October 29, 2021

ADDENDUM # 3
Little Hills Expressway and Mel Wetter Parkway Intersection Improvements
PROJECT NUMBER CMAQ #4917(602)
BID # 4527

The City of St. Charles is issuing this Addendum to the Little Hills Expressway and Mel Wetter Parkway Intersection Improvement Plan Sheets and Bid Documents. The purpose of the addendum is to make modifications to the stamped brick median, traffic control plans, sign posts, and the MSE wall. The revised bid information is as follows:

Updated Plan Wall Sheet – 10/21/2021

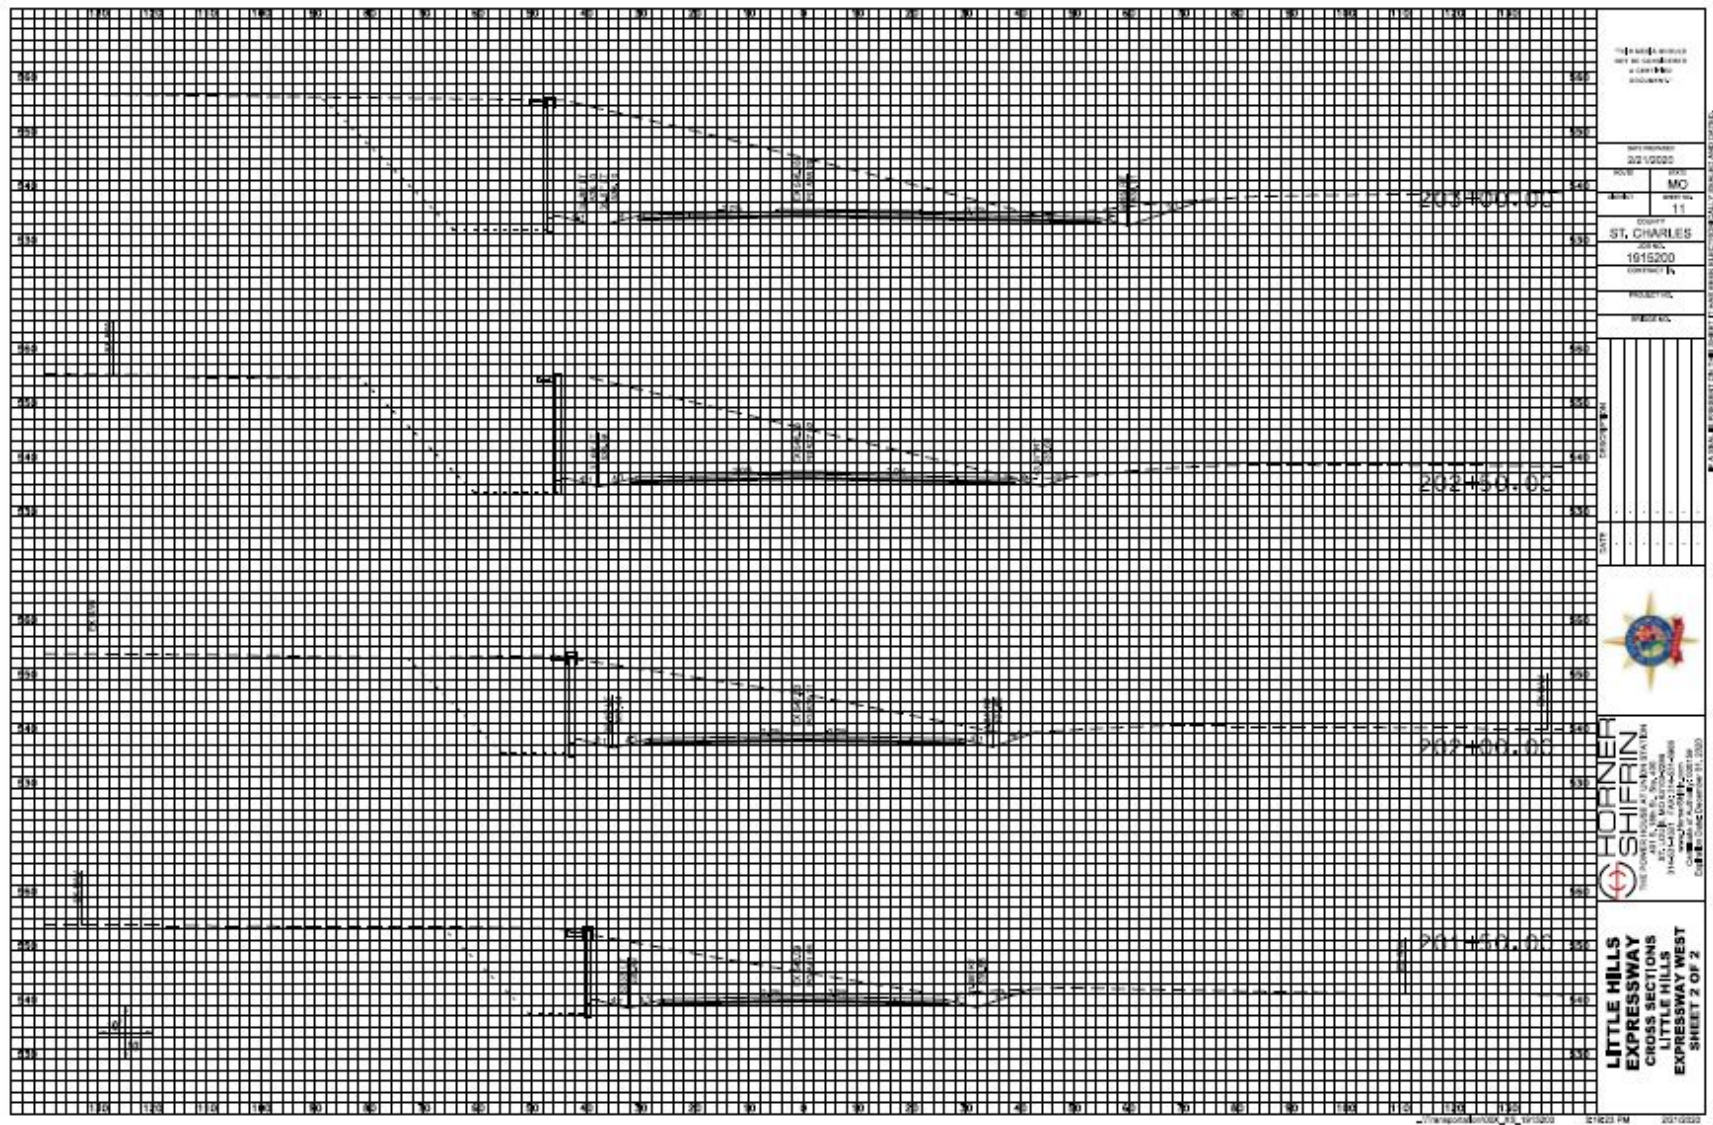
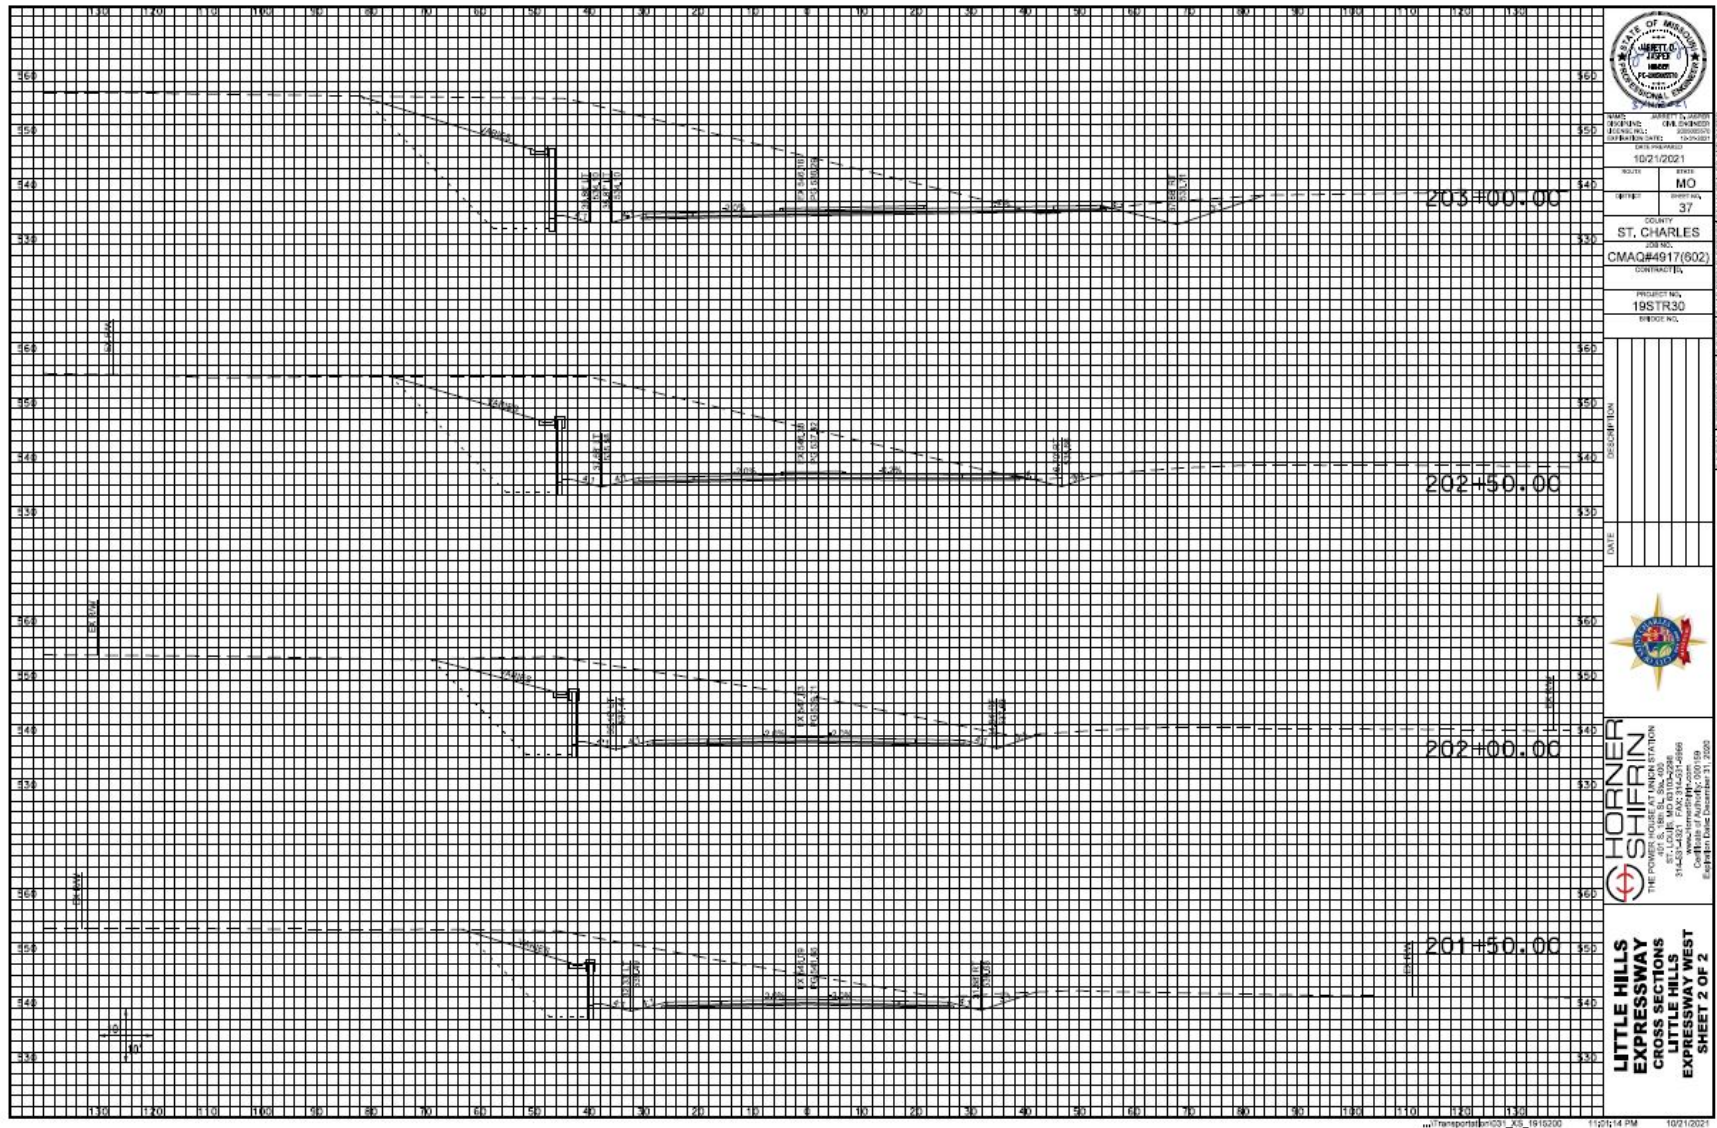
4. On plan sheet #24, the mechanically stabilized earth (MSE) wall height was shortened which reduced the MSE quantity from 8,802 to 5,894 SQFT. Soil reinforcement length changed from .7H to 1.0H which is shown on plan sheet #25.
 - a. Plan Sheets #2A, #2B, #4, #5, Cross section sheets #36 & 37, and the Report of Subsurface Exploration and Geotechnical Engineering have been updated.
5. The Project Bid Form has been revised to accommodate these changes.
